**Description of change**

FCC ID : YZP-VL1000

Base Model : LTD-VL1000

Variation Model : LTD-VL1110, LTD-VL1200

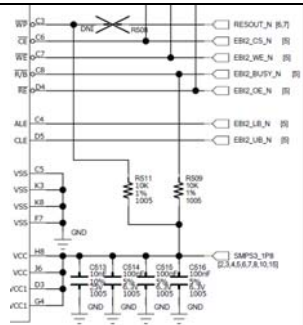
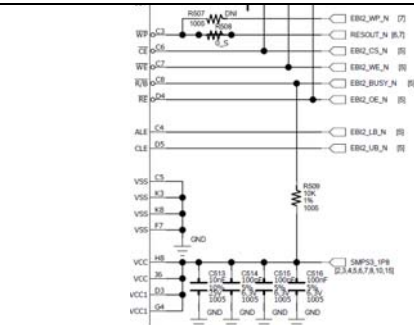
The differences between LTD-VL1000 and LTD-VL1110 are memory and changed resistors in below table.

LTD-VL1110	LTD-VL1000	Description of changes
S34MS02G200BHI00 (SPANSION, 2G NAND)	S34MS01G200BHI00 (SPANSION, 1G NAND)	Memory change (1G→2G)
		Add the Pull-up resistor (R511) for stabilization of the NAND memory.
Removed the R507	DNI	For System stabilization

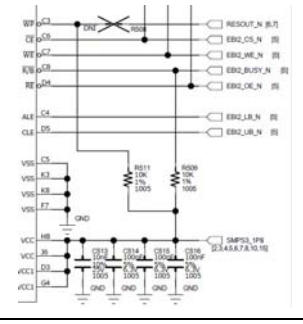
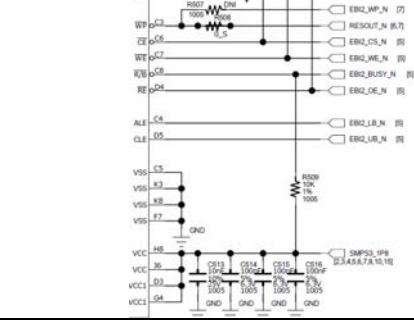
The difference between LTD-VL1000 and LTD-VL1200 is changed resistors in below table.

LTD-VL1200	LTD-VL1000	Description of changes
		Add the Pull-up resistor (R511) for stabilization of the NAND memory.
Removed R507	DNI	For System stabilization
